**AGENDA**  
August 11, 2015

# **SUBDIVISION REVIEW**

REFERENCE: Stone Subdivision Final Plat Submittal July 17, 2015

FROM: Lynn Vinzant; Community Development Director  
Bryce Wilcox; JUB Engineering

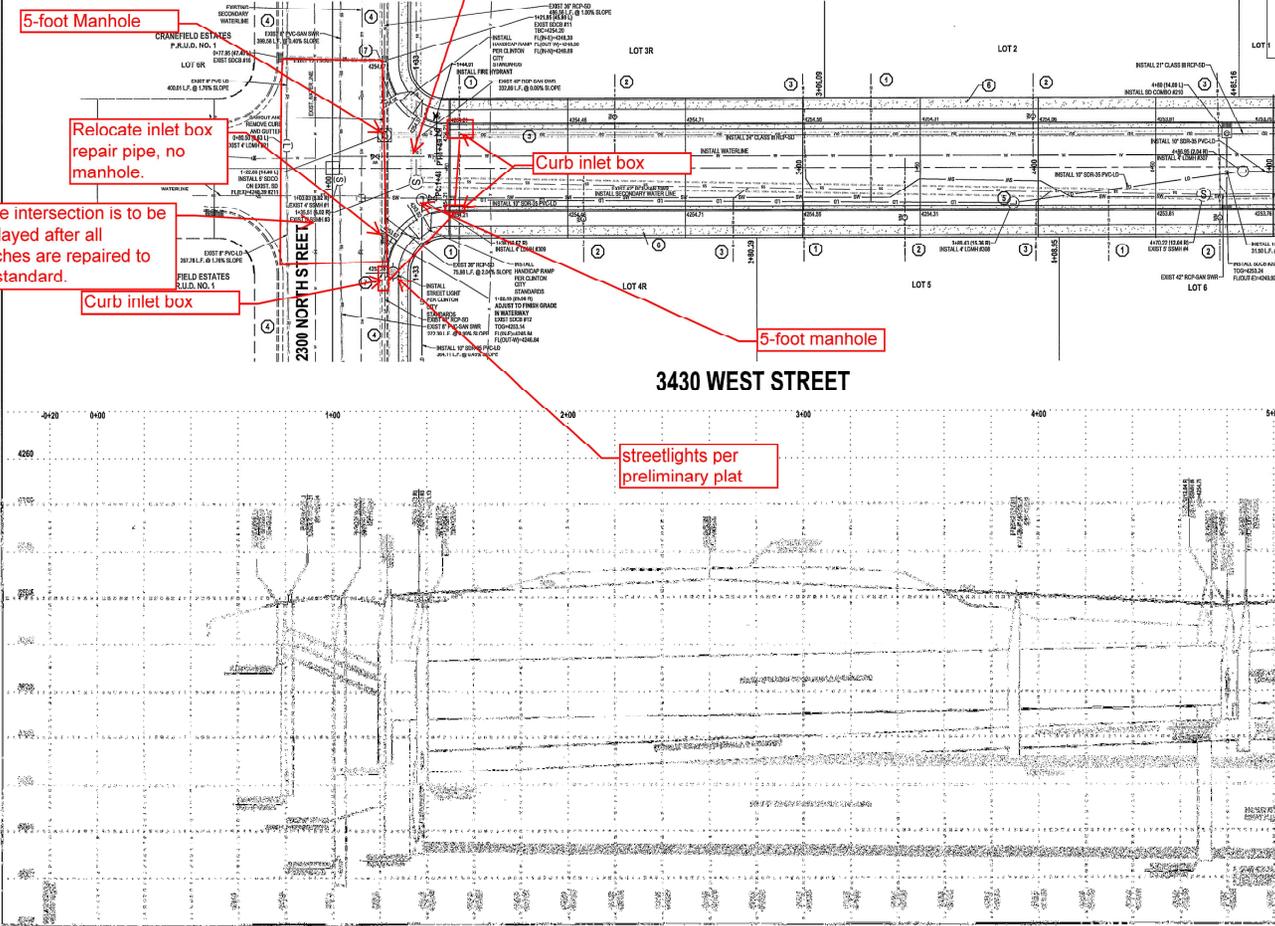
Entire intersection is to be overlaid after all trenches are repaired to city standard.

Curb inlet box

All water valves to be located at extended property line.

Curb inlet box
